UNITED STATES PATENT AND TRADEMARK OFFICE

Office Action Summary	Application No. 10/049,834	Applicant(s) SCHEIBE ET AL.	
	Examiner Jason J. Boeckmann	Art Unit 3752

DETAILED ACTION

Examiner's Marked Up Figure #3

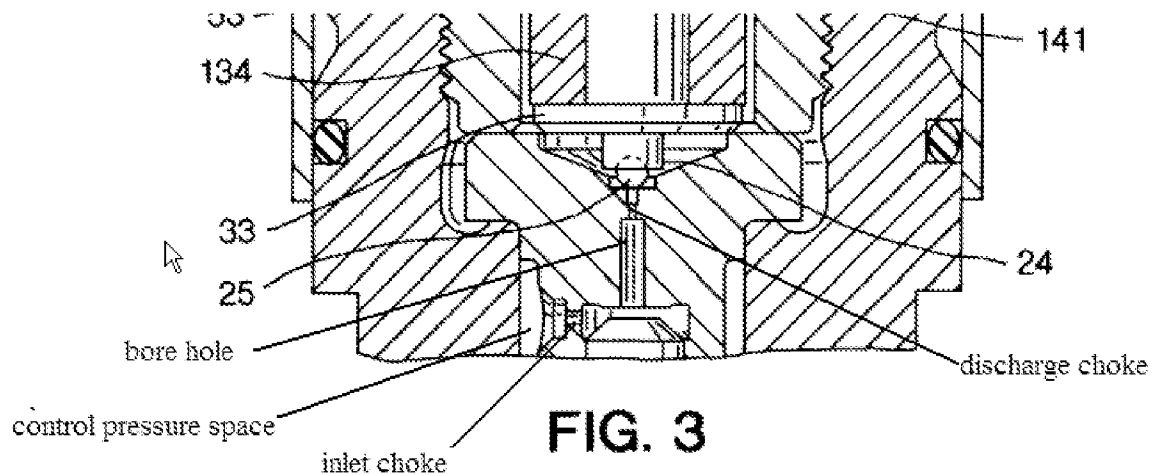
Regarding claims 14-19, and 31-37 the insert part (also forms a stop for the valve needle) is formed in two parts with a first part, which contains an opening for the passage fluid and a discharge or outlet choke (see examiners marked up figure 3) and a second part at the control pressure space side, with a bore hole (see examiners marked up figure 3) which connects the control pressure space (see examiners marked up figure 3) with an opening for the passage of fluid. The second part contains an inlet choke (see examiners marked up figure 3) near the bore hole (see examiners marked up figure 3). The pressure space is connected with an inlet choke and the rear end of the valve needle (see examiners marked up figure 3) averted from the nozzle needle seat surface lies in the control pressure space. The pressure insert part also including an inlet choke and an outlet or discharge choke (see figure below).
